PCN-149023

Product Change Notice

HSM9-C280

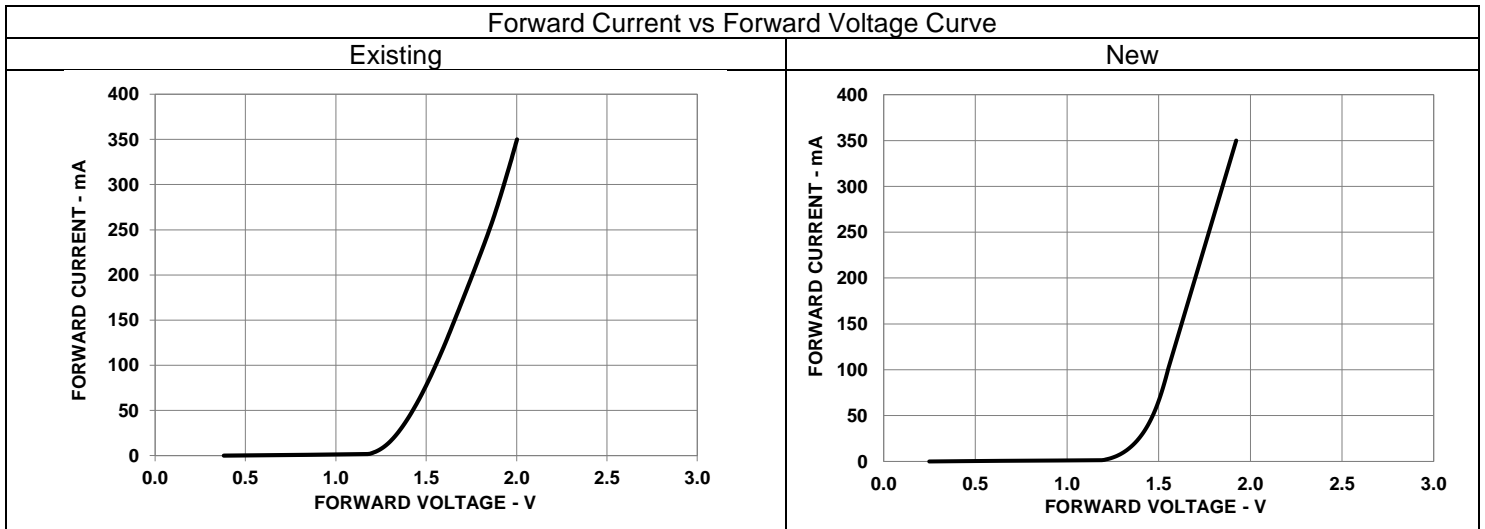
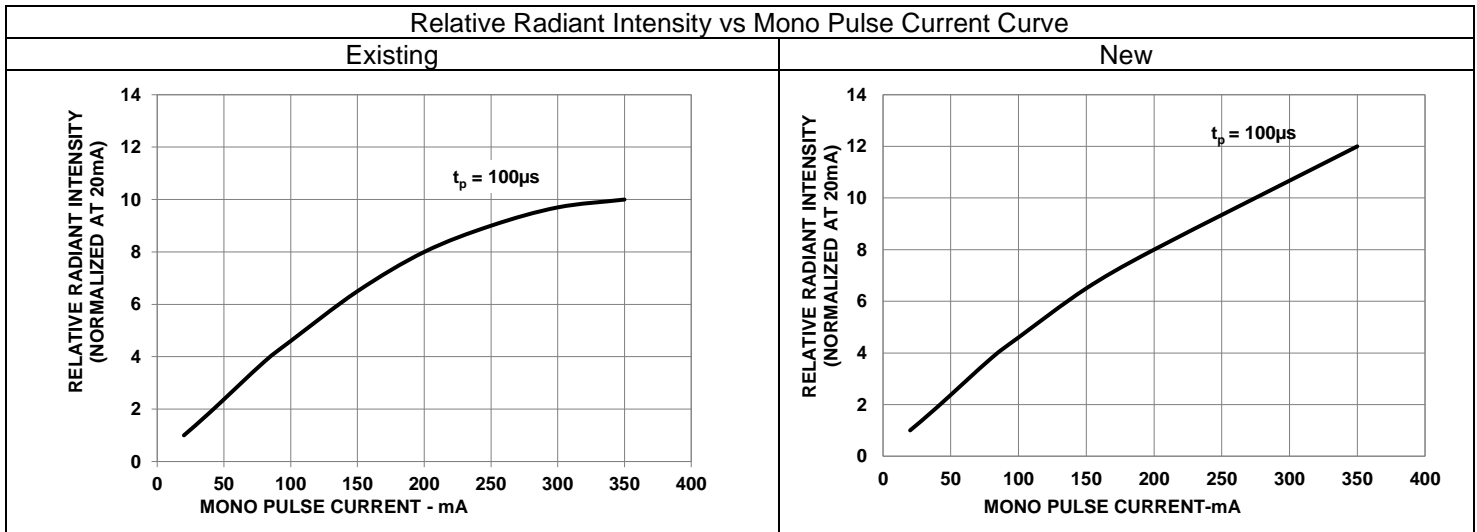
Alternate die source for affected part number listed below

The alternate die source is qualified per Broadcom’s qualification process and it meets Broadcom qualification requirements.

There is no change in fit, form, quality and reliability. New forward voltage curve and relative radiant intensity curve are as per table below.
